ADDENDUM NO. 1

LOWER VALLEY WATER DISTRICT

PANORAMA VILLAGE LIFT STATION 19 (PACKAGE 4)

BID No. 24-0105-01

JOB NO. 21-117
SHEET NUMBER C8.3

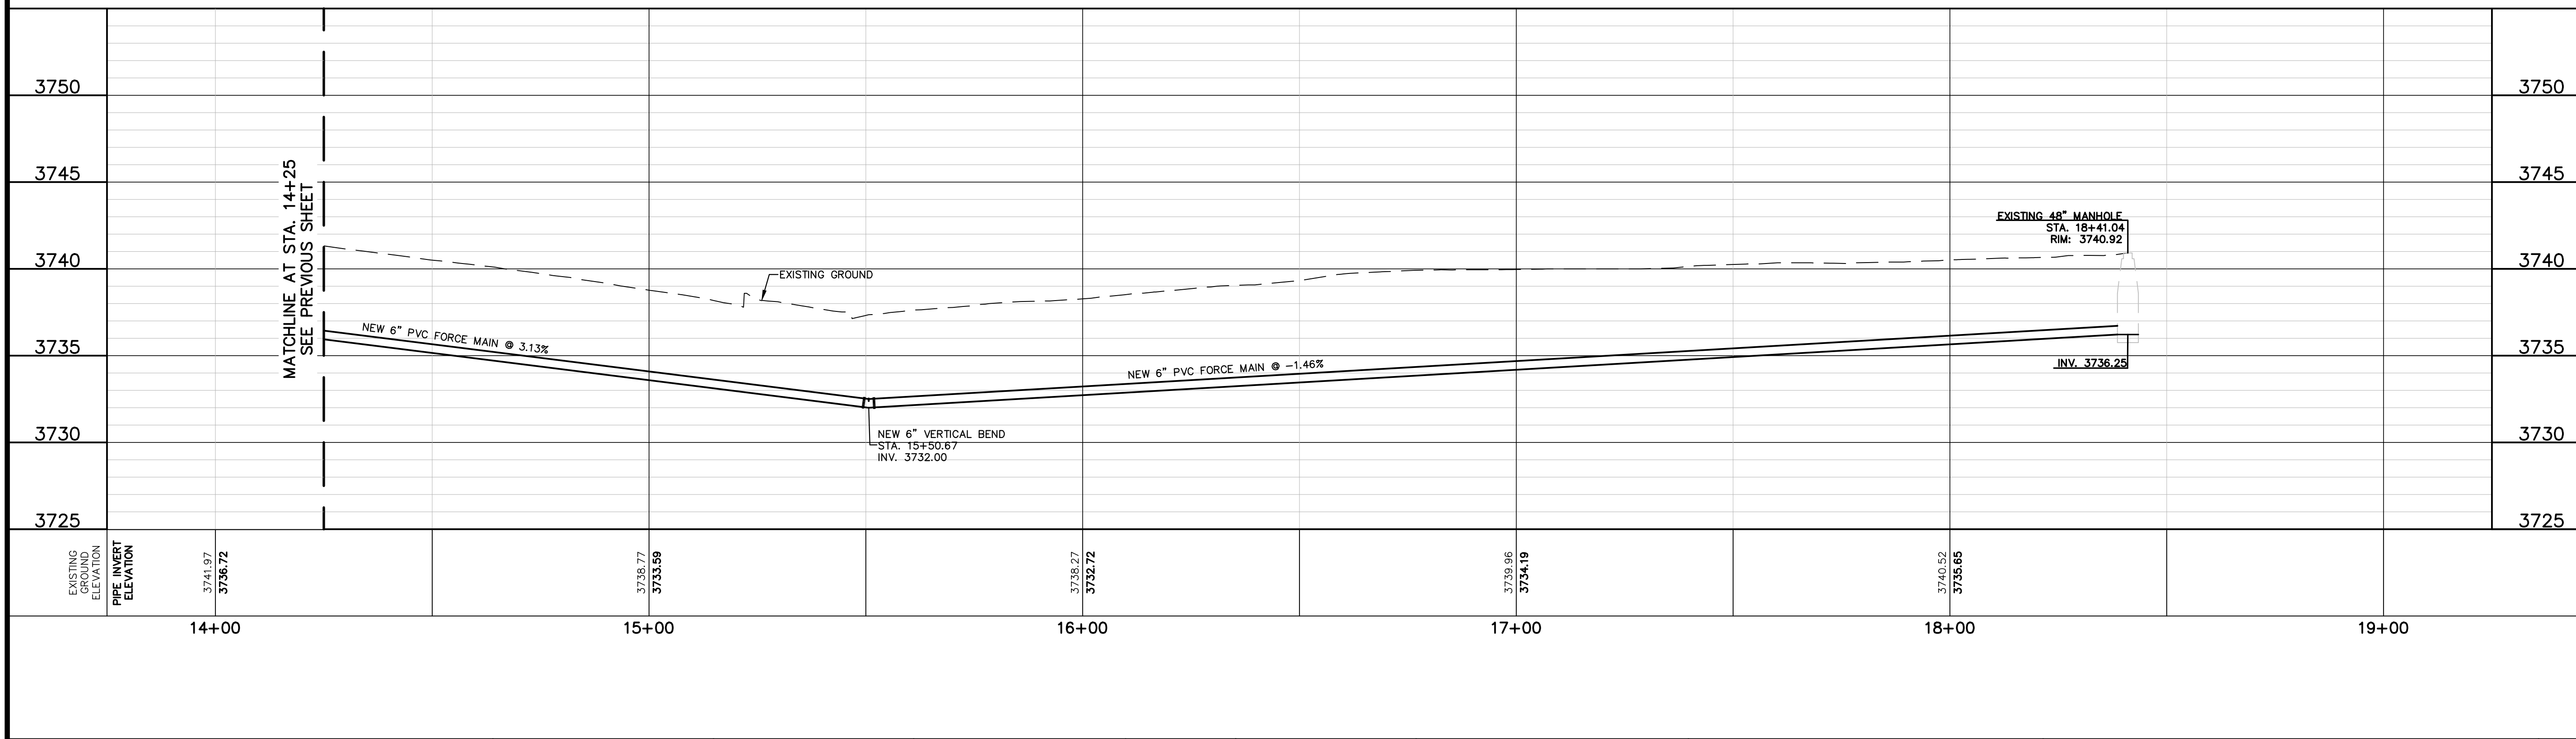
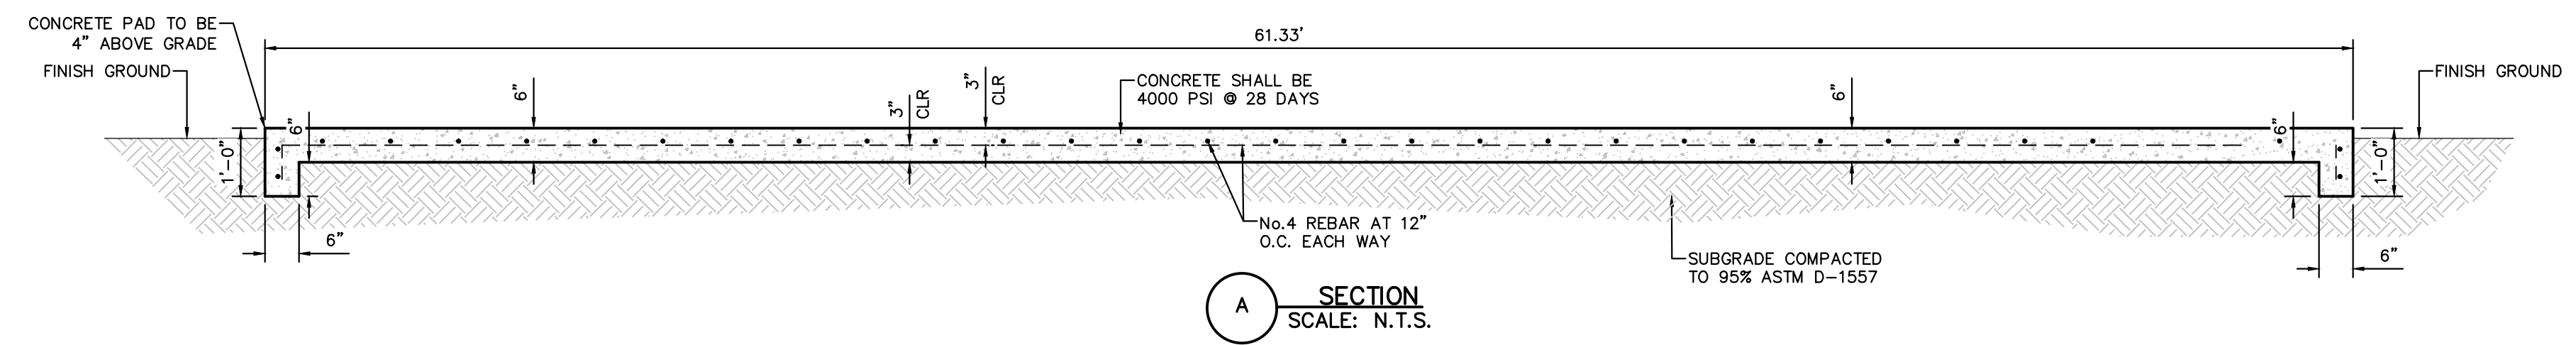
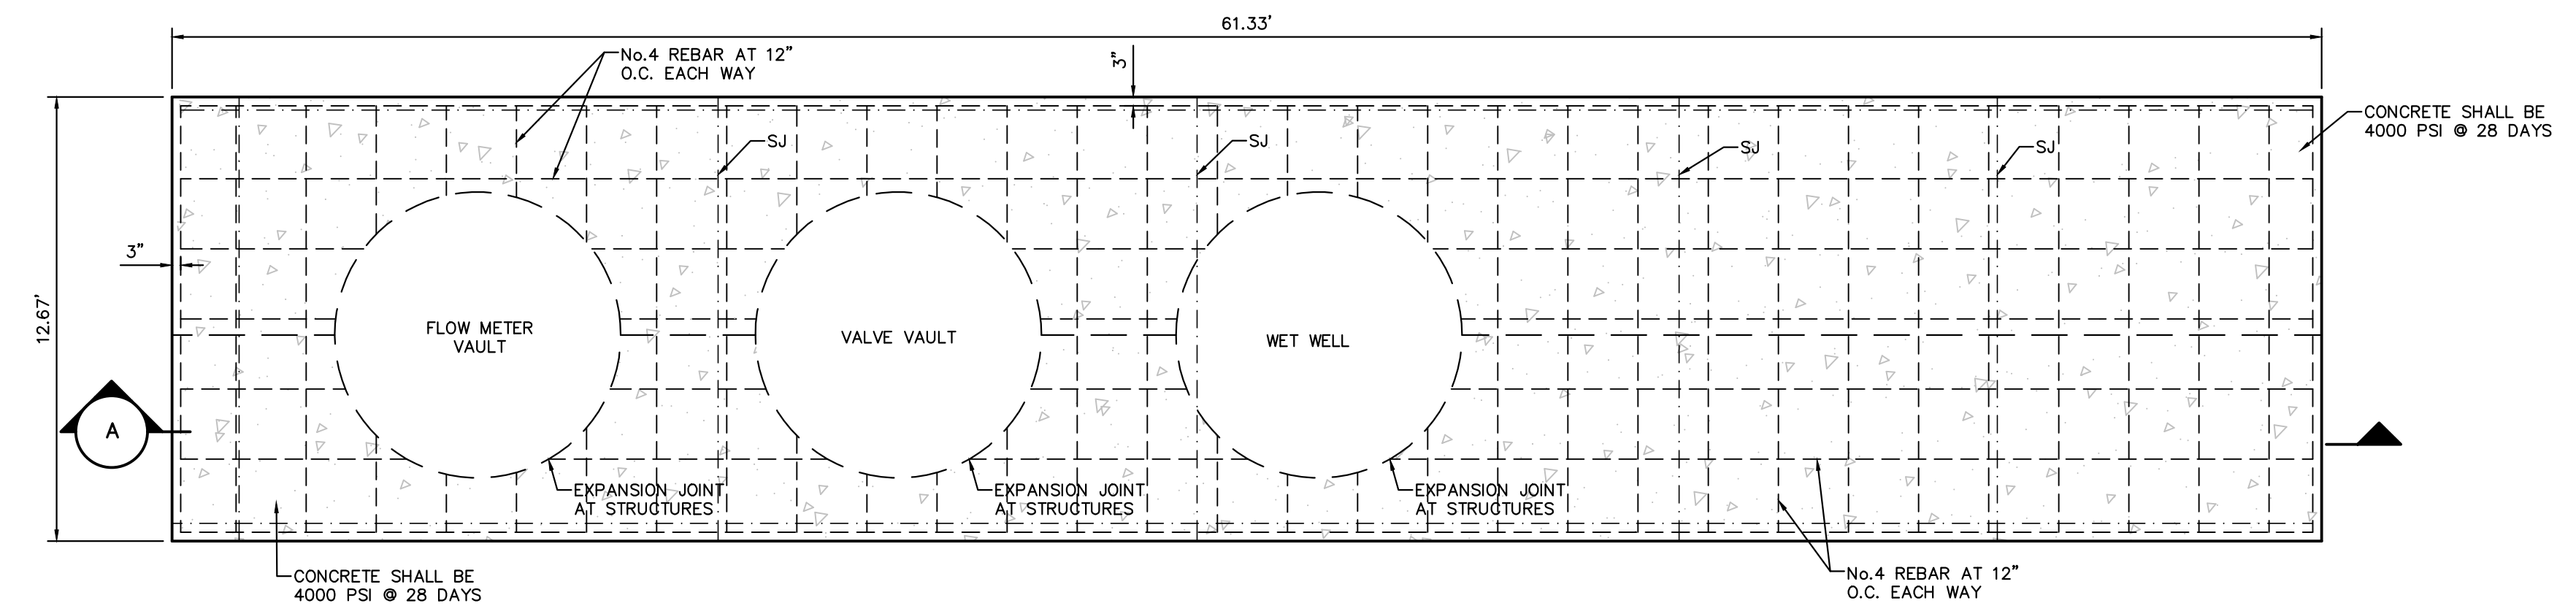
REV.	DATE	BY	DESCRIPTION
1	12/22/23	EC	AERIAL ADDED AND MODIFIED VIEWPORT

JOB NO. 21-117
SHEET NUMBER C12.1

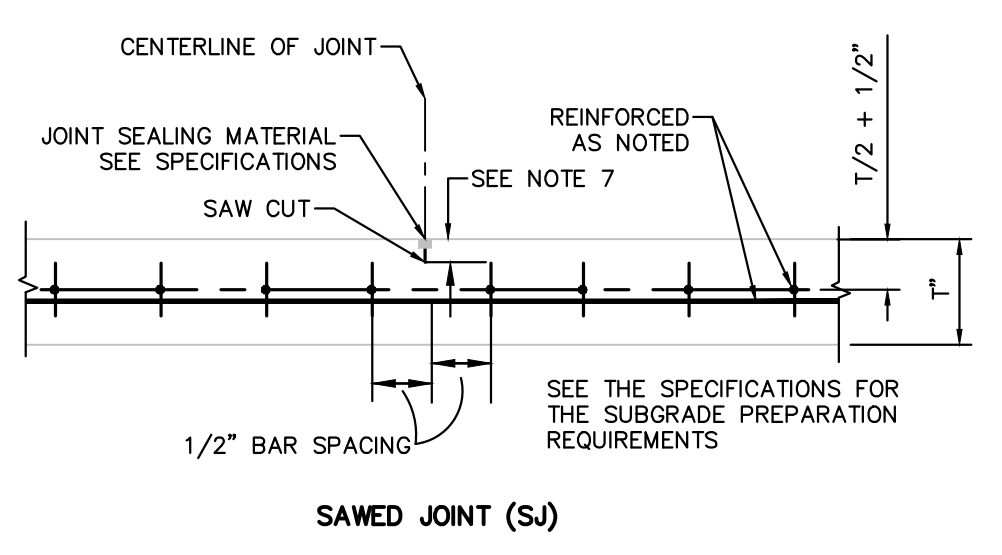
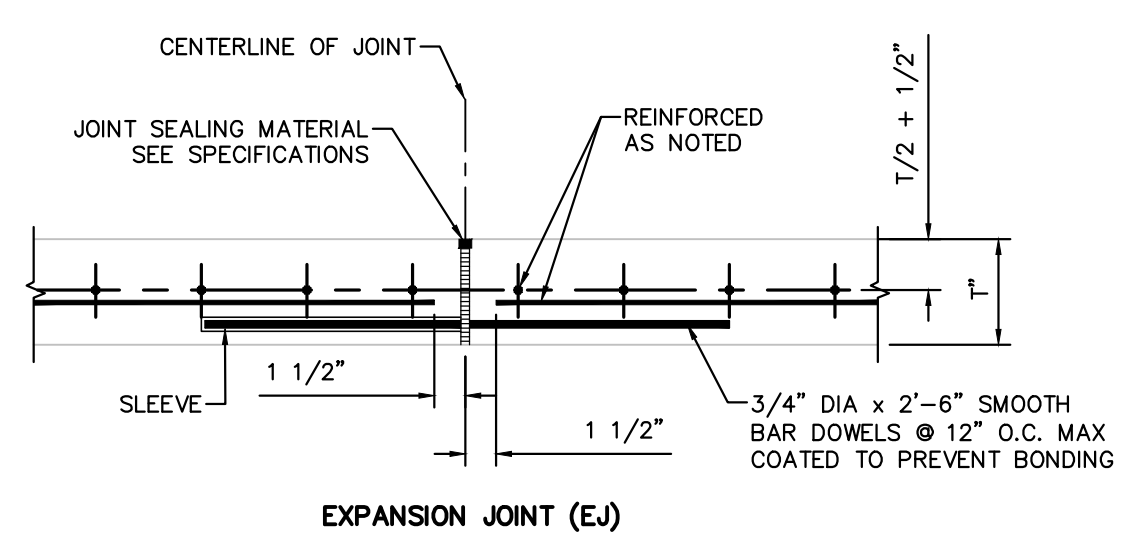
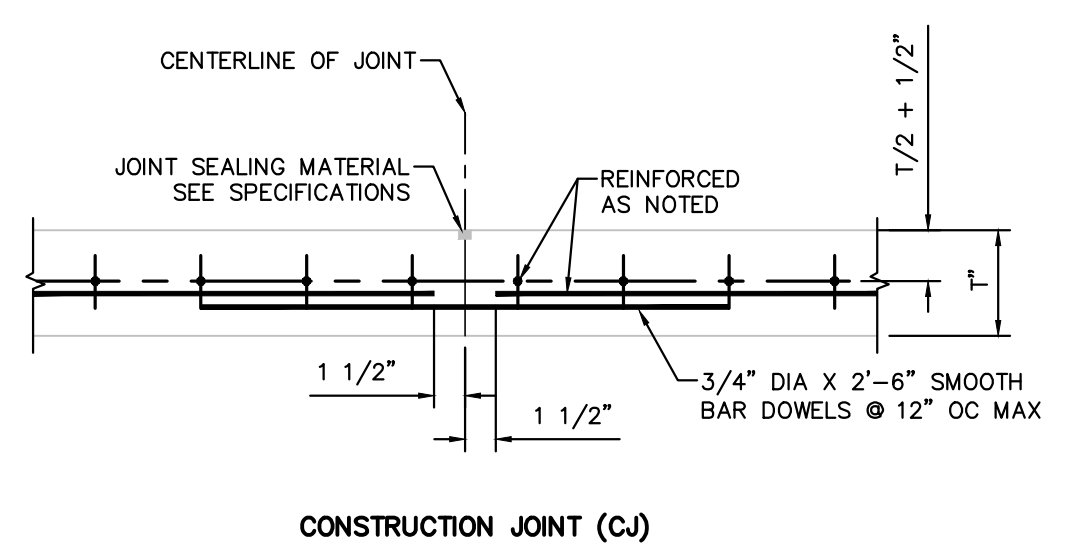
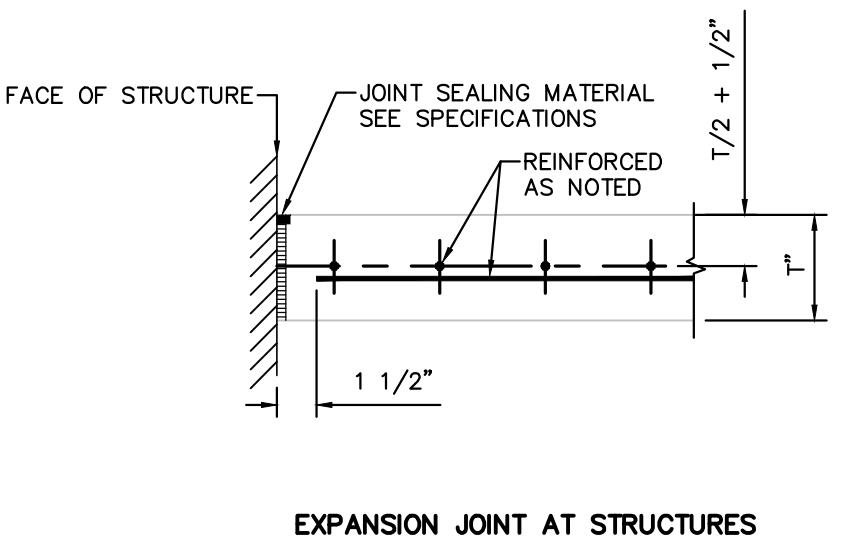
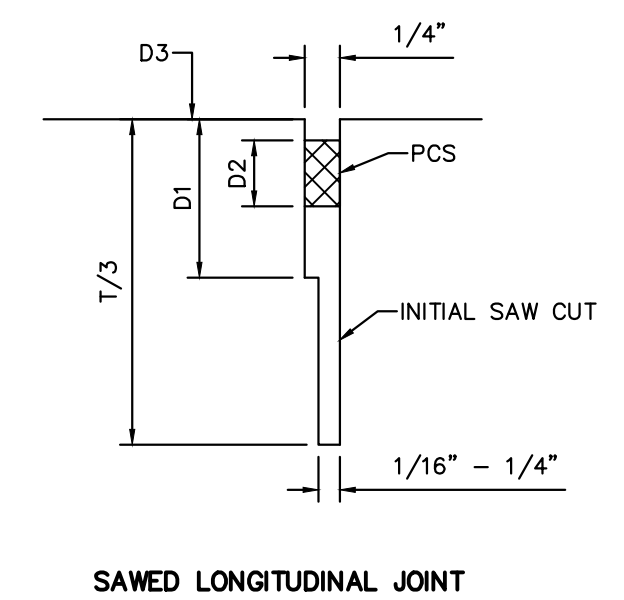
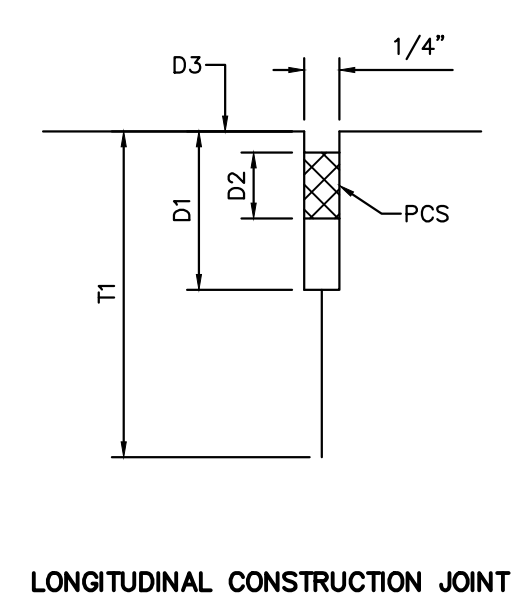
1	12/22/23	EC	CONCRETE SLAB DETAIL ADDED
REV.	DATE	BY	DESCRIPTION
